ADS IWG Working Document  
Change Proposal Form  
One major comment per form  
(Shaded blocks for use by the IWG Secretariat)

ADS-14-04/Rev.1

Minor revision of the description of Confirmatory testing scenario in 6.3.3.1.1

Figure 1 Traffic disturbance example 1: Other vehicles cutting in

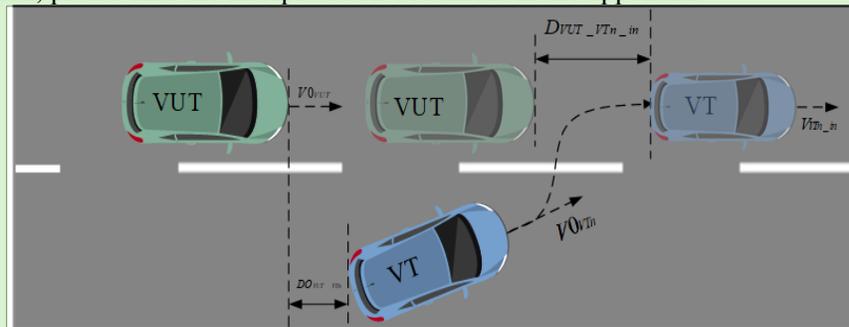
Traffic disturbance scenarios, including but not limited to behaviours in the presence of surrounding motor vehicles, vulnerable road users, and non-motorized vehicle, which includes "Situations with a large number of other road users", and specially indicate the trigger conditions for ADS safety concerns. More information, please find the interpretation document in the appendix.

c) Situations with a large number of other road users with traffic disturbance, unlikely road infrastructure, or abnormal geographic/environmental conditions,
